September 2, 2020

Re: **Nestucca Valley Elementary School (PWS ID #90595)
New Well #4 (SRC-AD) and Arsenic, Iron, and Manganese Treatment (EP-A)
Conditional Approval (PR #44-2019)**

Thank you for your submittal to the Oregon Health Authority's Drinking Water Services (DWS) of plan review information for the new well and AdEdge treatment system on behalf of the Nestucca Valley Elementary School in Tillamook County. The project includes the development of a new well #4 (SRC-AD) and treatment system (WTP-A/EP-A) to serve the school as shown in the schematics on page 7 of this letter.

System description:

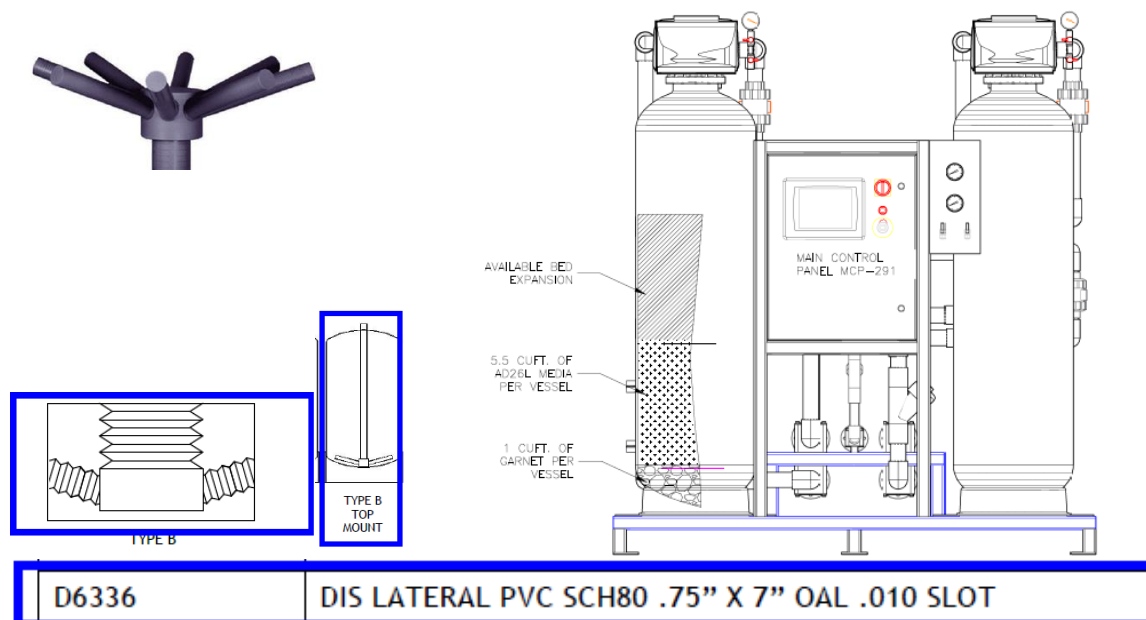
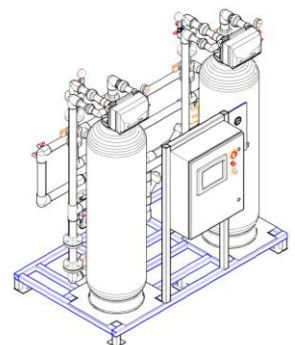
1. The pressure tank must have bypass piping, a way to drain it and a pressure gauge.
2. The Norwesco tank must have:
 - a. A vented lid w/integral screen designed for potable water applications or have separate vent pipe with downward turned elbow.

- b. Overflow piping that drains to daylight and terminates in screen or flap valve.
 - c. A drain to daylight (the overflow can tee into the drain line downstream of the drain shut-off valve and use the same discharge to daylight piping with a single flap valve and/or insect screen)

3. For the chlorination system:
 - a. A DPD type test kit for sodium hypochlorite monitoring is needed
 - b. Provide the make/model of disinfection pump to verify NSF-61

- c. Provide NSF-60 documentation of sodium hypochlorite
 - d. Demonstrate the chlorinator piping is designed to prevent contamination of the potable supply by backflow of untreated water or water having excessive chlorine (e.g., an air gap for filling the chlorine solution tank and/or an RP if potable site water is used as carry water for the chlorine, etc.).

- e. Demonstrate or describe how the disinfection injection will be proportional to plant flow.
4. An Operation and Maintenance manual is needed that addresses how to operate the arsenic treatment system, how and when to backwash system, and process control

6. Treated water lab test results showing the system is absent of coliform bacteria to demonstrate disinfection of new facilities and method of disinfection.
7. Demonstrate that the potable system (including wells #3 and #4 and the treatment system) are adequately protection from backflow contamination in accordance with [OAR 333-061-0070](#).
